TGPC comments on additional information

Oathill Planning Application 21/0050/CWS73M (notice dated 18 Dec 2023)

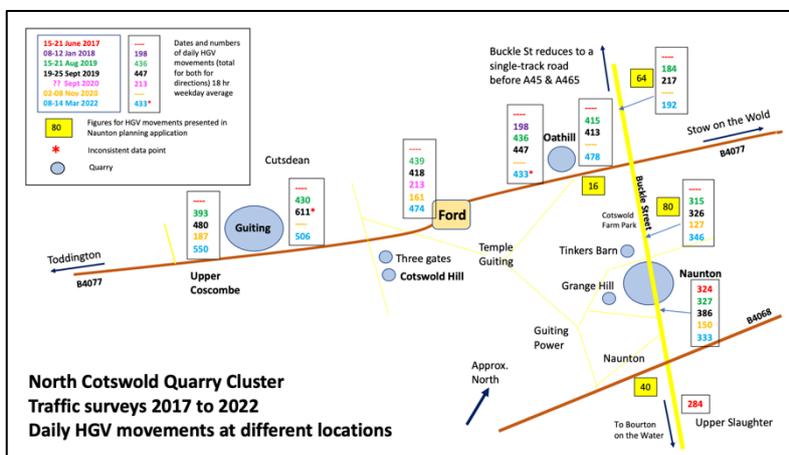
Recent planning applications illustrate the changes in production across the cluster between 2019 and 2023. Production at Naunton Quarry remains unchanged but the reopening of Guiting Quarry and importation of fill to Cotswold Hill Quarry add a significant number of HGVs on the B4077.

This is illustrated in the traffic counts presented as part of this Application taken in Aug & Sept 2019 and in March 2022. 2019 is significant as it is before Cotswold Hill started to import fill materials and before Guiting Quarry was reactivated. The March 2022 figures clearly show a significant increase in HGV movements. Each load will

result in two movements. The figures show total movements.

Not all of the figures are directly comparable; for example, the figure of 611 movements to the east of Guiting Quarry is not credible given the adjacent traffic counts. Similarly the figures to the west of Oathill quarry in March 2022 are not consistent with those observed in Ford. It is impossible to lose 40 HGVs on this section of road!... further investigation showed that the readings were taken on different dates.

The increase in HGV movements is illustrated in the attached graph.

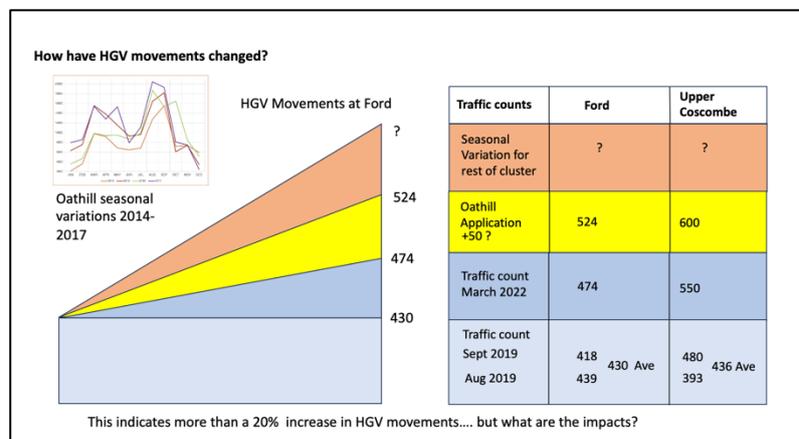
To keep things simple we have averaged the figures for Aug & Sept 2019. This shows a significant increase in HGV movements, of more than 10%, on the B4077 between 2019 and March 2022.

The proposed increase of 50 movements would normally add to these figures, as would seasonal variations from across the cluster in August and September. However, the Applicant has now stated that the figures in March 2022 already include the proposed increase. Production figures for Oathill from 2019 to 2022 have not been provided. Based on historic figures we could still expect September 2022 to be higher than March 2022.
